SUBJECT: LA-6 Model

DATE: March 1 , 1934

This Bulletin supplies detailed supplementary information to that issued in Machine Service Bulletins No. 161, Supplements A, B, C and D, and 165, 167 and 177.

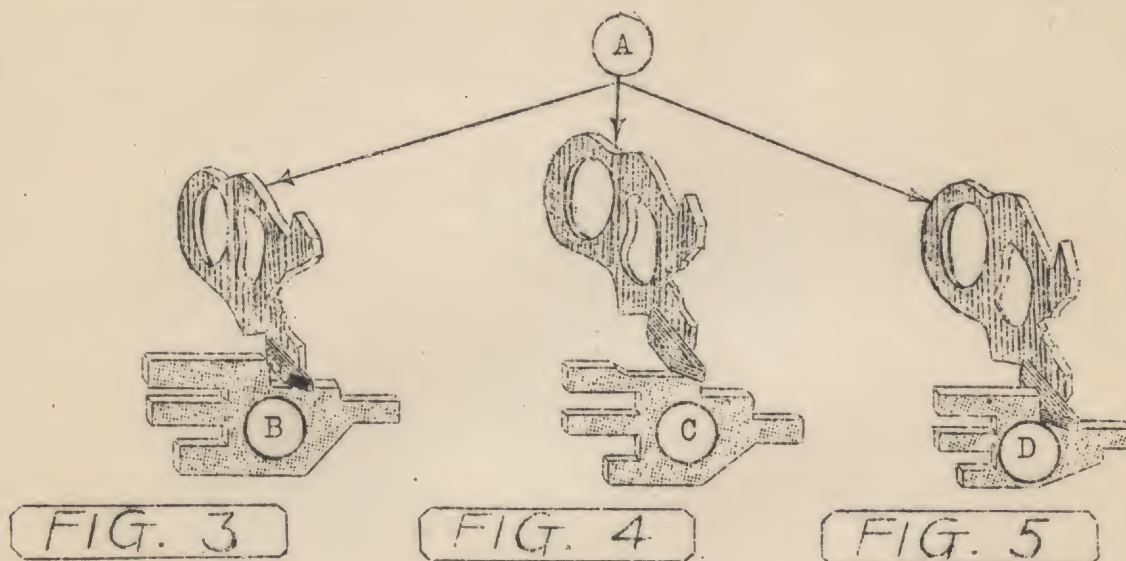
An improvement has been made in the carrying dogs by adding a small amount of stock on the top of the dogs at the points where they contact the feet of the wedges. See (B) and (D), Figure 6. In LA-6 models, due to the use of round tooth gears in the extra carry unit, it is necessary to set a slightly higher mesh between the dial gears and intermediate gears than in other L models. This higher mesh causes the wedges (A) to be depressed slightly later by the carrying pins than with the deep mesh, and we have found that this delay, even though it is slight, causes the wedges, when they are depressed, to strike the top of the dogs rather than to drop in front of them. In order to overcome this condition, we have added a small amount of metal to the top of the dogs so that the delay in depressing the wedge is compensated.

Figure 3 illustrates the correct engagement of wedges (A) with the new style 2416 dogs (B).

Figure 4 shows the incorrect condition caused by the wedges (A) dropping late and riding on top of the 2416 old style dogs (C).

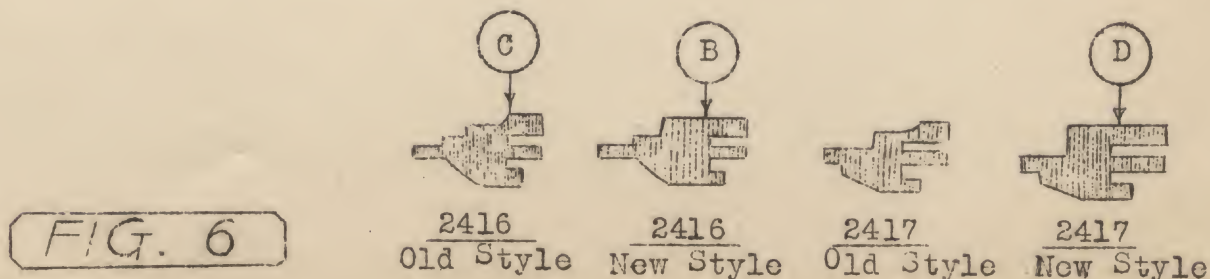
Figure 5 illustrates the correct engagement of the wedges (A) with the new style 2417 dogs (D).

FIG. 7

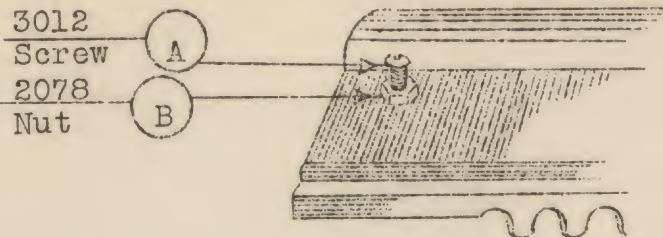
Set screw (A) has been provided to limit the movement of the trip rod (H) when the constant key is depressed.

If the correct number is not registered when setting the constant into the carriage and the machine is without this feature, install screw (A) and nut (B) by following the instructions listed below. NOTE: After installing screw (A) and nut (B), if the correct number does not register when setting the constant into the carriage, adjust screw (A) up or down until the trouble is corrected.

- 1 - Position the rocker arm assembly (D), as shown. Raise stud (C) with the fingers as far as possible. In doing so, lug (F) contacts the carriage case (E) and leaves a slight mark as indicated by (G).
- 2 - Center punch this mark.
- 3 - Drill a hole through the case with a #50 drill, using the center punch indent as a guide.
- 4 - From the outside of the case enlarge the hole with a #49 drill and tap it with a 2-64 tap.
- 5 - Install nut (B) on screw (A) and insert (A) in the case to suit and tighten (B) securely.

NOTE: To allow for free movement of rocker arm (D) after installing screw (A), it may be necessary to grind (D) at (F).

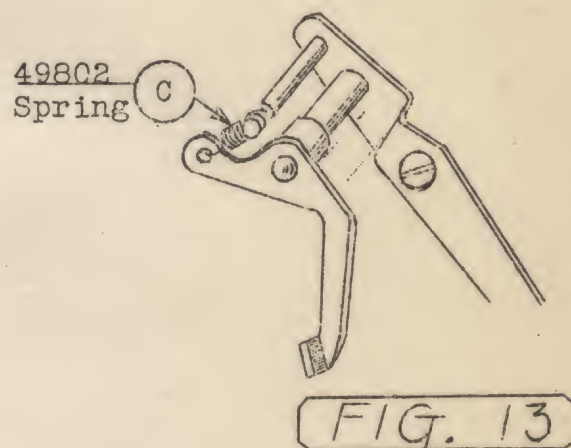
The left hand ends of the dial collars (D) have been reduced slightly in diameter so that they may be assembled more easily. If collars (D) have a flat on the flange which form a bearing for the index ring (B) the corners (E) on the left side should be broken with a stone.

After the shaft is assembled, if the dial is held and the clear pin displaced either way with the finger, it should immediately snap back into position when the finger is removed. If the ring (B) is sluggish it is caused by too harsh an action; i.e., there are burrs, or the ring is rubbing against the inside of the dial. Also, it should be possible to turn the dial by means of the clear pin without an appreciable displacement of the pin in relation to the dial. If this cannot be done, it shows that the spring (A) is too weak. If the dial mechanism appears to be correct and the correct number is not registered when setting the constant in the carriage, the condition may be remedied at times by setting the carriage slightly forward or rearward.

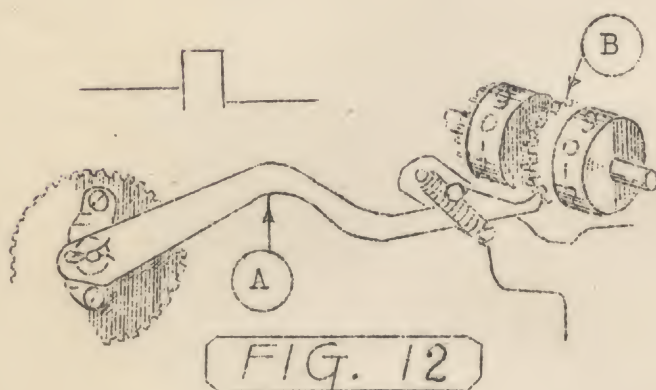
If the Figure "9" is left in the multiplication counting dial and it is certain that the carriage locks and lock cams are adjusted and function properly (See Plate 27, Machine Service Bulletin No. 161-B) the trouble is caused by insufficient impulse for the carriage shift. Any hesitation in the shift may cause a "9" to be left in the dial. Therefore the automatic shifting mechanism on the left hand side of the machine should be adjusted to give more power to the shift.

NOTE: Delay in shifting causes only the "9's" to be left in the dial.

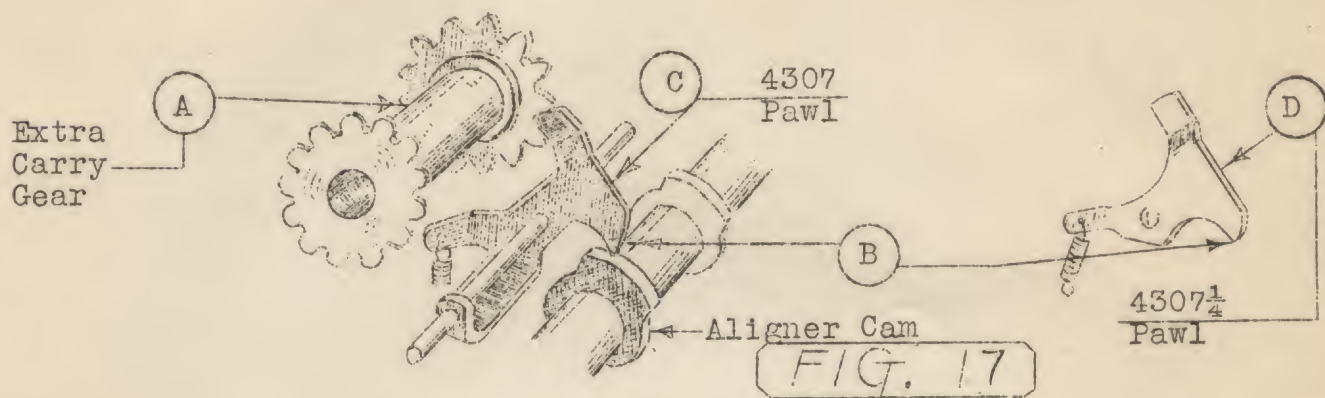
When the aligner cams are in position to lock the pawls, the extra carry gears should have a very slight amount of play. To overcome a condition whereby too much clearance exists at this point, peen the pawl (C) or (D) at (B) to suit. In some cases the installing of new pawls may remedy this condition.

Often, binds in the extra carry gears (A) are the cause of the unit locking up. Therefore, it is advisable to determine the freedom of these gears by disengaging pawls (C) and (D) from them.

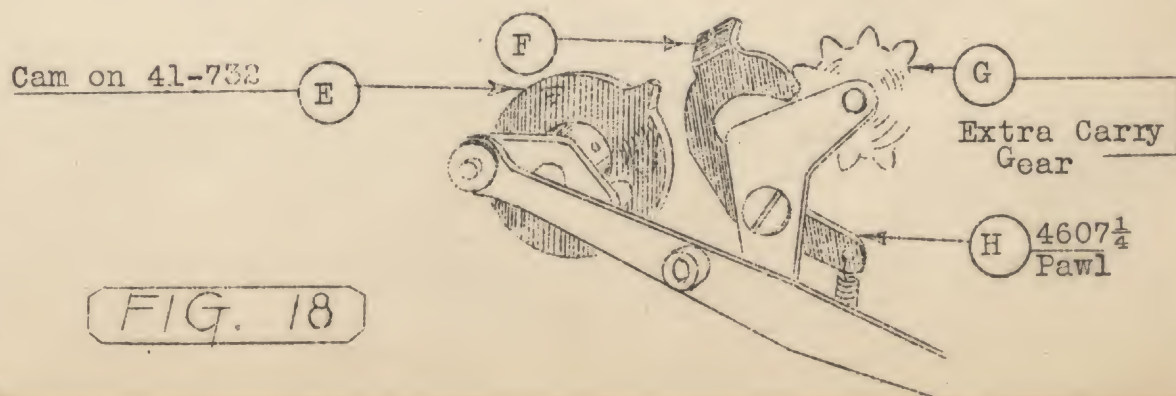
A condition occurs occasionally wherein one of the pawls (C) is locked against the extra carry gear before the cam (E) on the 41-732 of the carry shaft has positioned pawl (H) into full engagement with the First extra carry gear (G). To remedy such a condition bend lug (F) slightly forward or rearward to hasten its engagement with (E) in accordance with the direction in which the machine was operating when this trouble occurred.

Plate 9

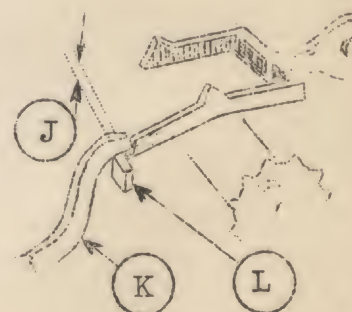
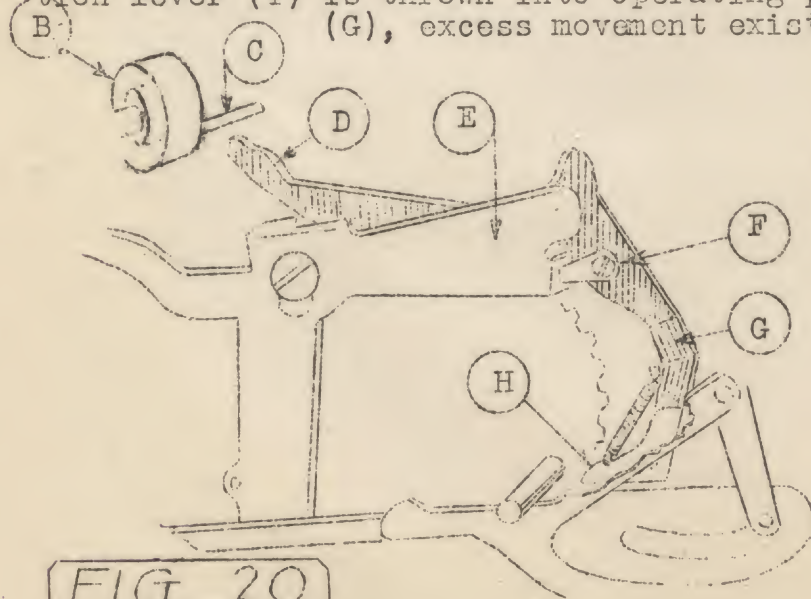
The eccentric screw stud (E) on Plate 9, should be adjusted so that roller (Q) does not contact the aperture in link (F) when slide (G) is unlatched from (P). Machines not equipped with a 49105 stopping blank shown as (M), should have this feature installed. After installing blank (M), neutralize the division and multiplication levers and adjust blank (M) to the end of link (F) so that .015 clearance exists at (U). After the proper adjustment has been made, tighten the tie rod screw (N) securely. To test this adjustment throw the division lever in and snap it out of the divide position. When it is restored to neutral, link (F) should not contact roller (Q) enough to cause any upward movement of (G).

Screw (R) should be adjusted in slot (S) so that when the multiplication lever (T) is thrown into operating position and roller (Q) raises (G), excess movement exists after (G) latches on (P).

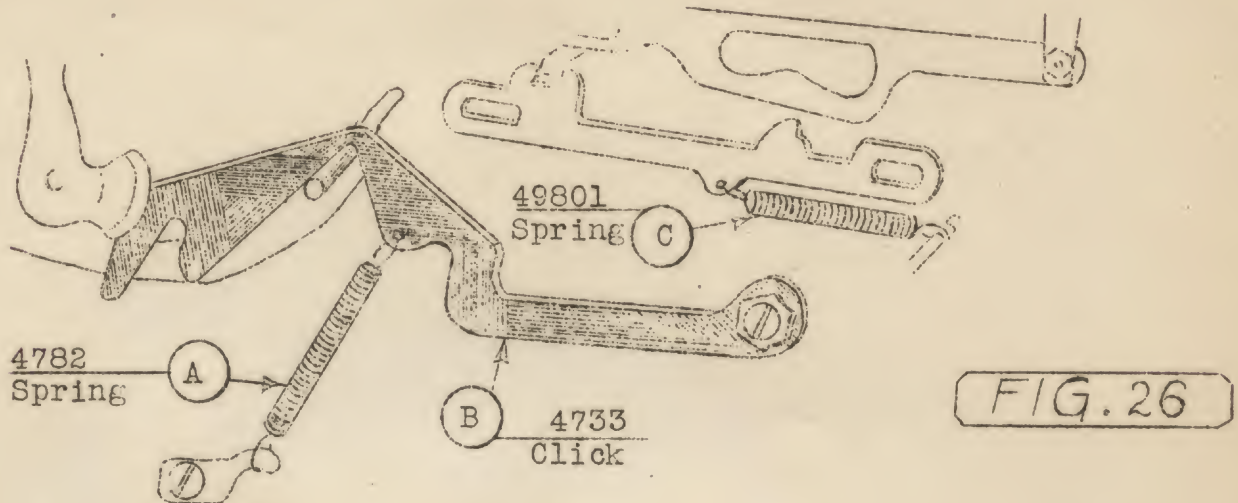
The new style division lever click (B) should be installed in all machines. (See Machine Service Bulletin No. 161-B, Plate 28.) Upon installing the new click it is important that spring (A), 4782, is of standard length and tension. Therefore, if the original spring has been shortened, replace it. It is also necessary to replace (C), 49801, with a 788 spring.

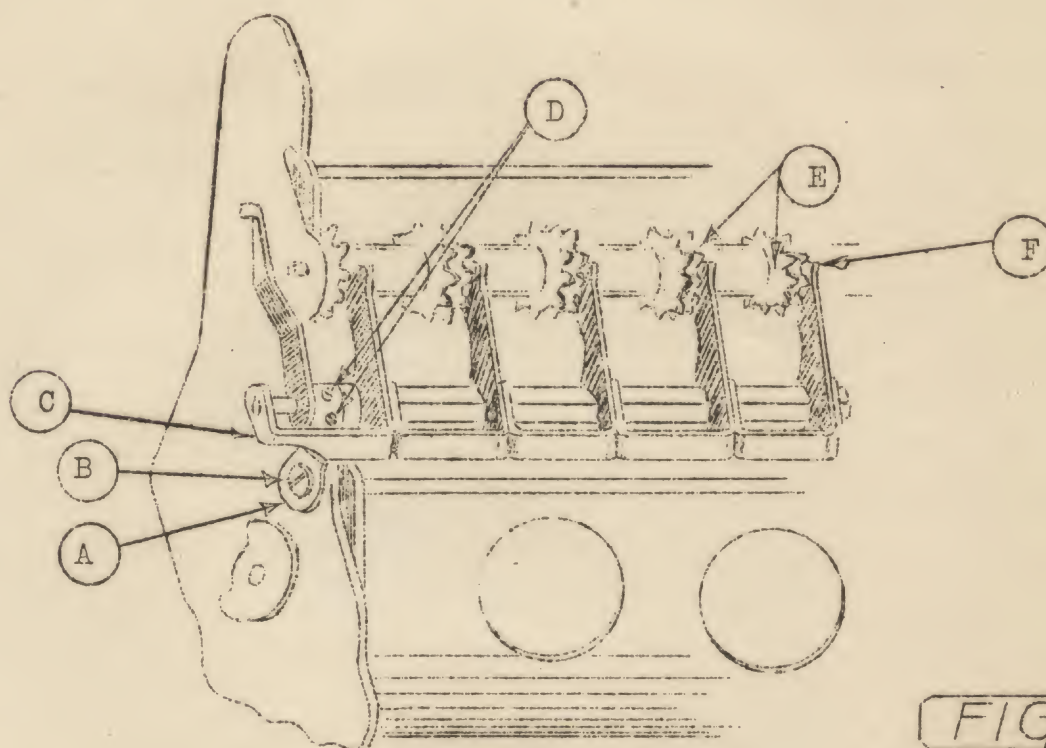
If at the end of subtraction in automatic division, or at the end of the forward correction cycle, the machine should continue to run, trip levers (F) are adjusted too low.

If in automatic division, the machine should reverse itself before the division is complete in a column, the trip levers (F) are adjusted too high.

The points of trip levers (F) should extend slightly below the surface of the teeth on gears (E). Holding the points at this position, loosen (B) and place blank (A) up against the fold of arm (C) and tighten screw (B) securely. Loosen screws (D) and position arms (F) upward or downward in relation to the regular trip lever. After the desired adjustment has been made tighten screws (D) securely.
